CITY OF CHARLES TOWN
PLANNING COMMISSION
AGENDA • MARCH 24, 2025

Commission Review:SLD2025-01 Huntfield Rec. Center - Final Plan Amendment

Final Plans Change Review

Request by DR Acquisitions to modify a final plan for Huntfield Recreation Center Plans. The changes include altering the facilities layout, parking arrangements, access points, and landscaping.

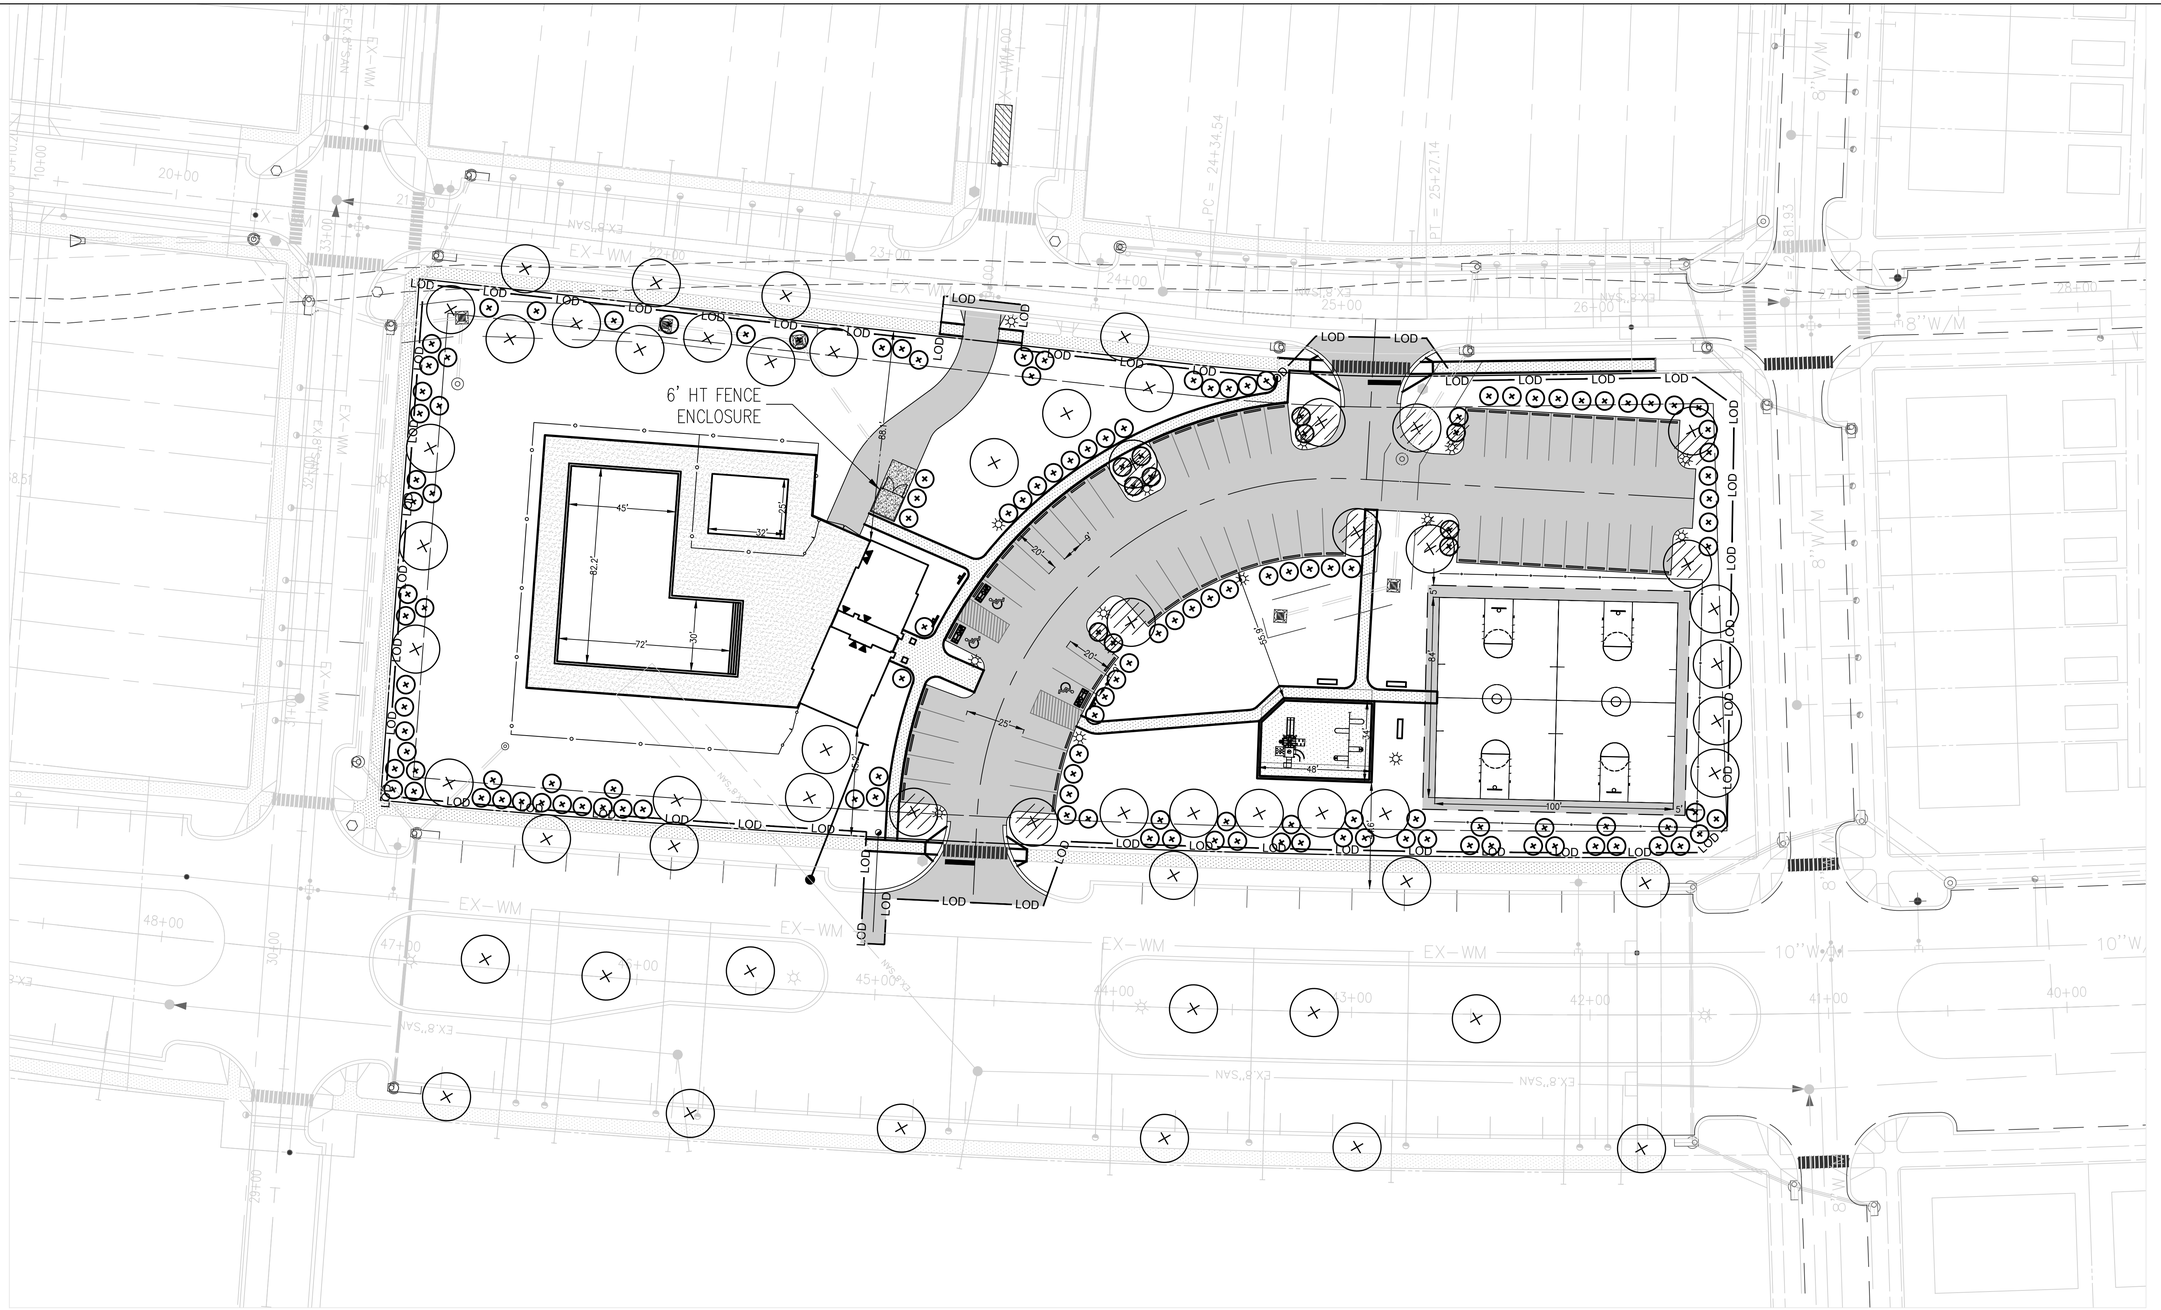
1) Fence three (3) sides of the basketball court that faces the roads and parking lot
2) Patio area for pools to be increased to at least 20-25 ft.
3) Reconfigure the parking lot for pedestrian travelers
4) Contain children's pool by barrier from main pool
5) Confirmation that the landscaping for trees on Prospect medians will come later
6) Confirm if shrubs are in planters.

1. Added a four foot tall fence around the basketball court on the three sides facing parking and roads.
2. Added a grass seating area with a depth of 20 feet from the edge of the decking around the pool. Issues with the grading of the property prevent expansion of the decking area.
3. Reconfigure the pedestrian path to allow for more direct access across the parking lot from the tot lot side.
4. Added a fence and gate around the children's pool.
5. The proposed landscaping along Prospect Blvd is not affected by these final plan amendments, and will be planted as shown in the 2007 plan set.
6. Applicant confirmed that landscaping will be planted in the ground, not planters, per the approved 2006 and 2007 plan sets.

NEWBURY STREET
PROSPECT HILL BOULEVARD
POOL (WATER ELEVATION= 552.08)
SEE SHEET 4 FOR POOL GRADING DETAIL
POOL BLDG
KIDDIE POOL
DUMPSTER AND PAD (SHEET 15 OF 15)
LOADING ZONE & EMERGENCY ACCESS
5' CONCRETE SIDEWALK

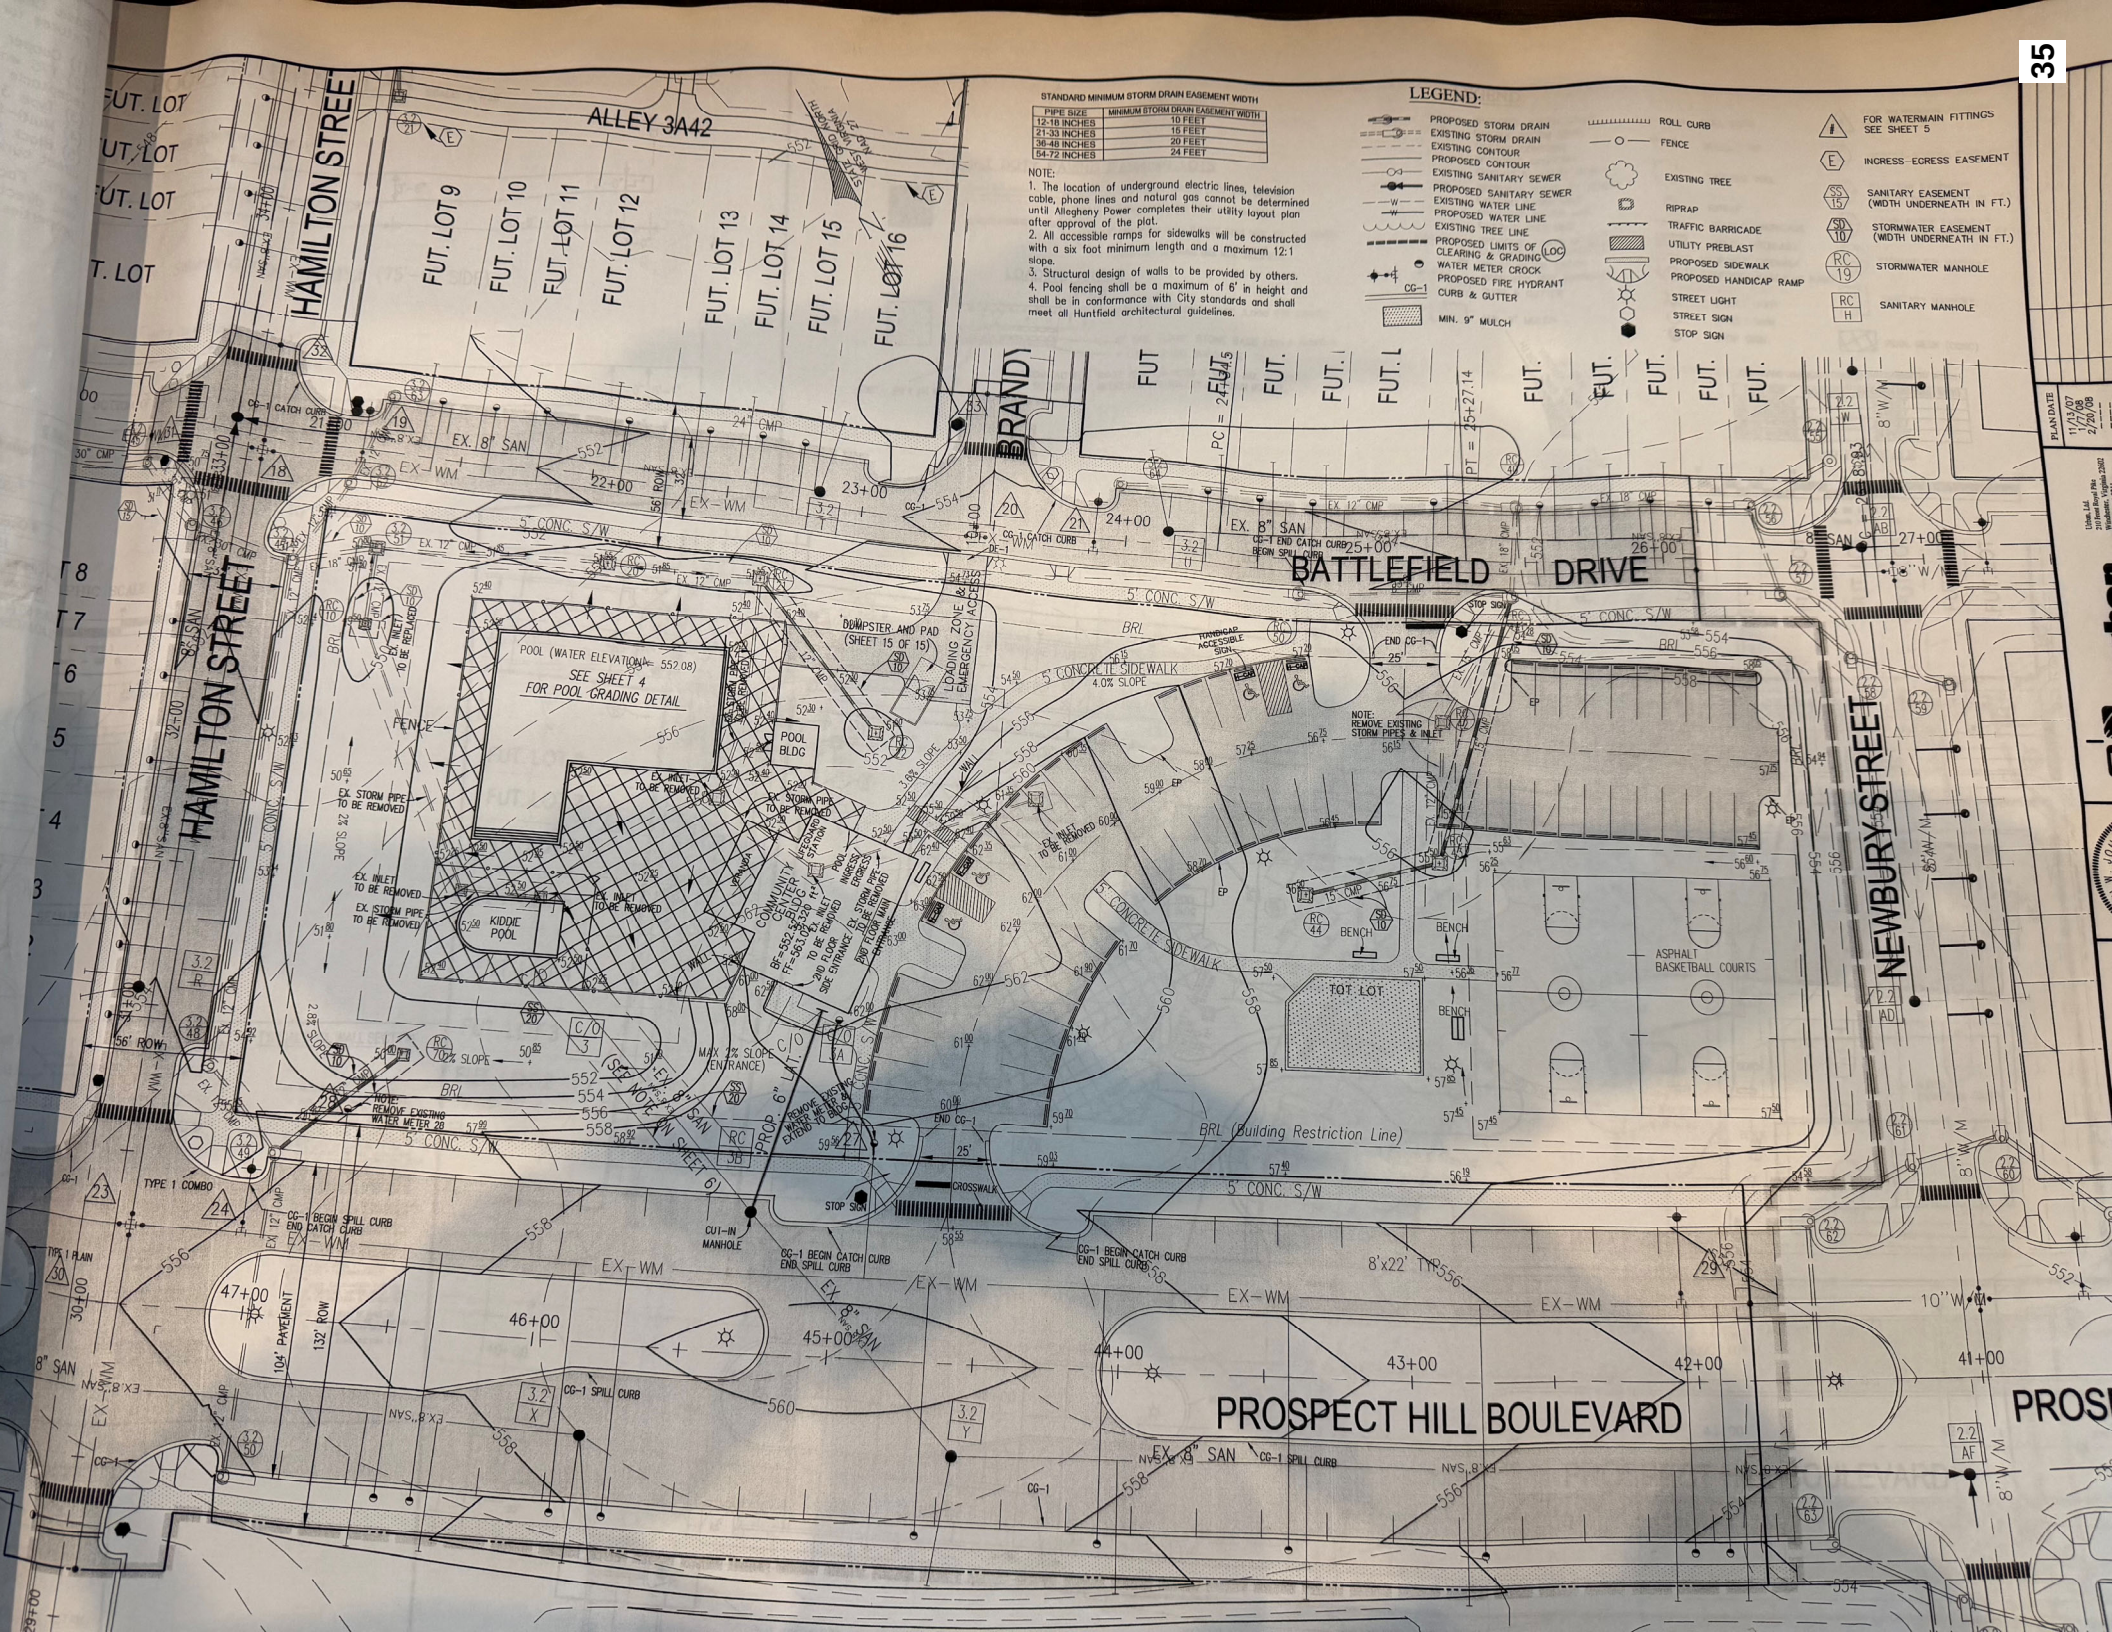
- Widen the fencing around the pool deck to provide a grass strip along the outside, additionally to provide a grass seating area. Grading challenges prohibit the decking to be extended, but a larger grass area inside the fence has been provided to allow for additional seating.

- **They want the kiddie pool to be fenced off from the main pool to prevent potential child drownings if a kid tries to go from the kiddie pool to the main pool without supervision.**
  - A fence with gated access has been provided around the kiddie pool.
- **Please confirm that the median on Prospect Blvd is included in the plan set. If so, it needs to be landscaped per the 2007 plan set.**
  - The landscaping plan from the approved plan dated 2/20/08 will be followed. This has been added into the updated plan set as originally shown.
